Application Number:	AWDM/1058/24	Recommendation - APPROVE
Site:	Former 51 Old Fort Road, Shoreham-By-Sea, West Sussex	
Proposal:	Application to vary conditions 1 & 15 of approved AWDM/2007/21 to enable floor level of the ground floor living rooms to be set as built at 5.91 metres AOD and for the lower ground floor to be habitable	
Applicant:	Mr and Mrs David and Brenda Collins	Ward: Marine Adur
Agent:	Mr James Breckell	
Case Officer:	Hannah Barker

The Environment Agency - Comments dated 17th October 2024

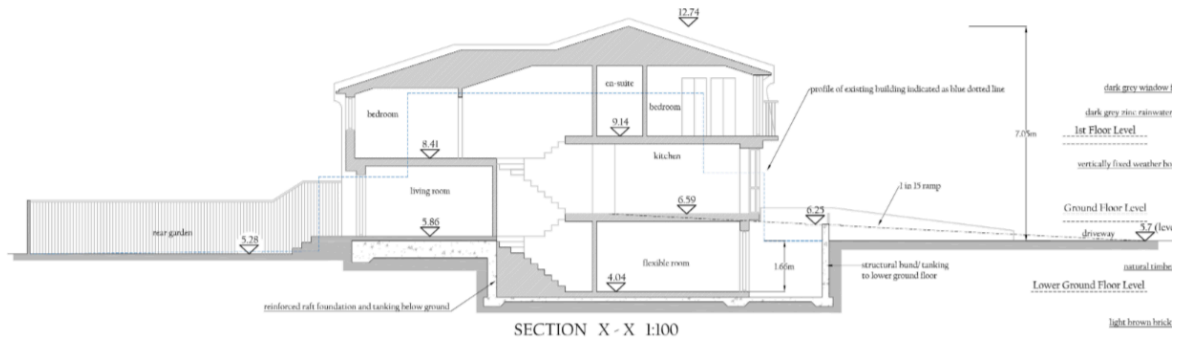
Since the committee meeting the Council has also engaged an independent surveyor to check the floor levels of the completed building on site, which are shown on the submitted cross-section drawing (below). The survey confirms that the ground floor levels are accurate but that the lower ground floor/basement is 0.18m lower than that shown on the plans, (a site measurement of 3.86m AOD compared with 4.04m AOD on the plan). An amended plan has been requested from the applicant, to reflect this 'as-built' basement level.

In consideration of this difference, it is noted that the approved planning condition is only concerned with the height of the ground floor and not the lower ground floor. The approved Flood Risk Assessment (FRA) for the development stated:

"The lower ground floor of each unit will be protected by higher levels around the perimeter of the units. This can be seen most easily in the proposed section drawing in Appendix C, there is no route for flood water to enter either unit."

Although 0.18m the difference in the level of the basement is not governed by the planning condition, the Environment Agency (EA) and WSP have been informed. The EA has repeated its advice of 17th October, i.e. *Our only stipulation in this regard is that it is not used for sleeping accommodation. Any response from WSP will be reported as an update.*
